Rahmat Sweaters (BD) Ltd Logos Printing & Design Ltd

Telirchala, Mouchak, Kaliakoir, Gazipur
(24.03152N, 90.30217E)

9th April 2014

Observations

Tested Columns

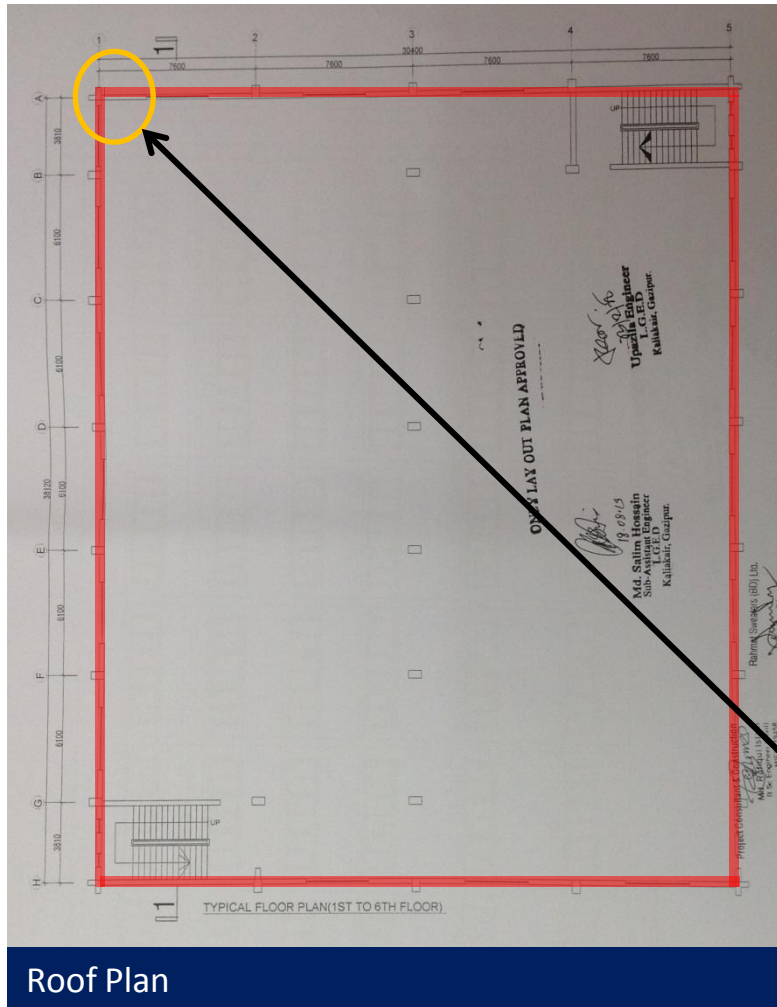
Stress Levels in Columns

Cursory calculations indicate that the working stresses of the columns are at a very high level. Detail Engineering Assessment required.

Brick aggregate was observed in the RC columns, which coincides with the information gathered during the interview that brick chips were used in all concrete elements. Mild steel reinforcement ($f_y = 40000\text{psi}$) was noted in the Structural Drawings, and the number of bars shown in the drawings coincides with the number of bars observed at Ground Floor level using the Ferros scanner. The size of the columns measured on site also appears to coincide with the drawings.

Item No.	Observation	Recommended Action Plan	Recommended Timeline
1	Stress levels in Columns	Factory Engineer to review design, loads and columns stresses in all columns.	Immediate - Now
2	Stress levels in Columns	Verify insitu concrete stresses either by 100mm diameter cores or existing cylinder strength data for cores from min. 4 no. columns. Verify grade of steel reinforcement used.	Immediate - Now
3	Stress levels in Columns	A Detail Engineering Assessment of Factory to be commenced, see attached Scope	Immediate - Now
4	Stress levels in Columns	Detail Engineering Assessment to be completed.	6-weeks
5	Stress levels in Columns	Make structural alterations as advised by Engineer.	6-weeks
6	Stress levels in Columns	Produce and actively manage a loading plan for all floor plates within the factory giving consideration to floor capacity and column capacity.	6-weeks
7	Stress levels in Columns	Continue to implement load plan	6-months

Cracking to underside of 5th Floor slab

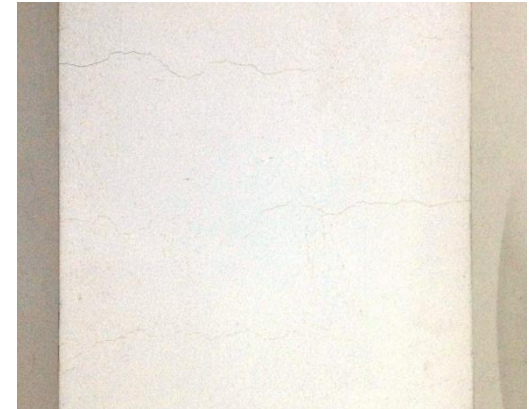
Hairline cracking in beams and some slab soffits at 2nd to 5th Floor levels

Hairline cracks were noted to the underside of beams and slabs at 2nd, 3rd, 4th and 5th Floor levels. Building Engineer to investigate and carry out remedial works to the structure as required.

Item No.	Observation	Recommended Action Plan	Recommended Timeline
10	Hairline cracking in beams and some slab soffits at 2nd to 5th Floor levels	Factory Engineer to investigate if the cracking is structural or exists only in the render, as part of the Detail Engineering Assessment.	6-weeks
11	Hairline cracking in beams and some slab soffits at 2nd to 5th Floor levels	Carry out any remedial work as directed by the Engineer.	6-months
12	Apparently non-engineered roof structures.	Factory Engineer to check the capacity of the lightweight roofs and make any necessary alterations.	6-months

Lightweight Steel Roofs

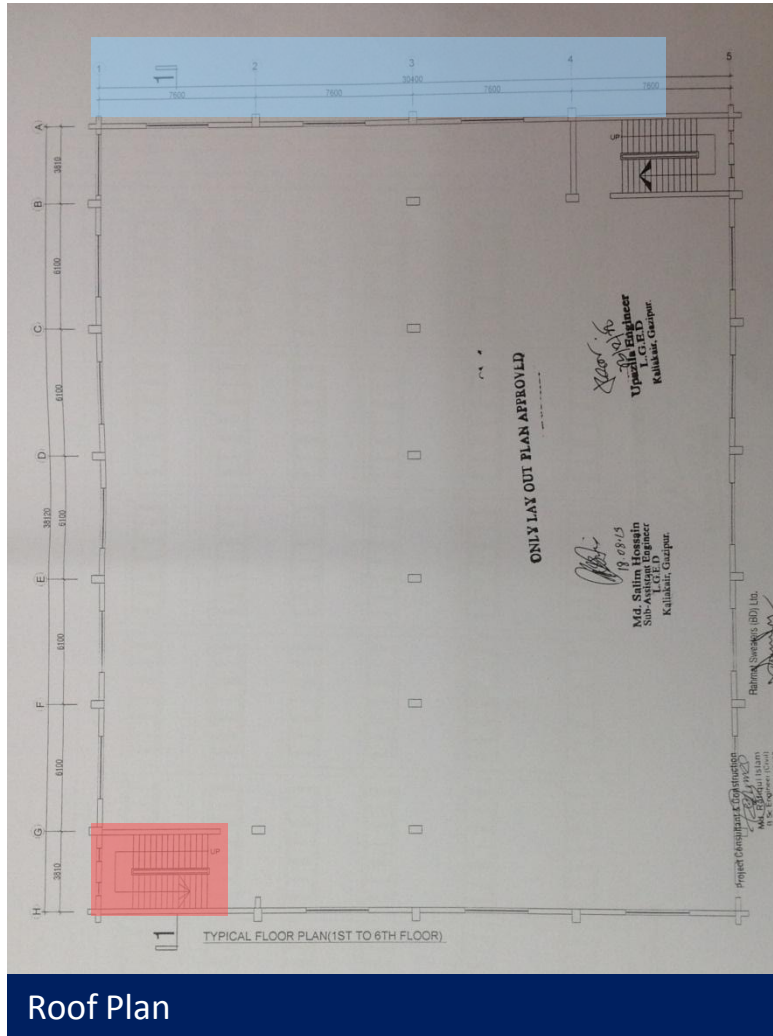
Apparently non-engineered roof structures

Building Engineer to review the design of the lightweight roof structures to the Ground Floor Boiler / Chemical rooms to the West of the building and to the South-East staircore roof, and to implement any upgrade works as required.
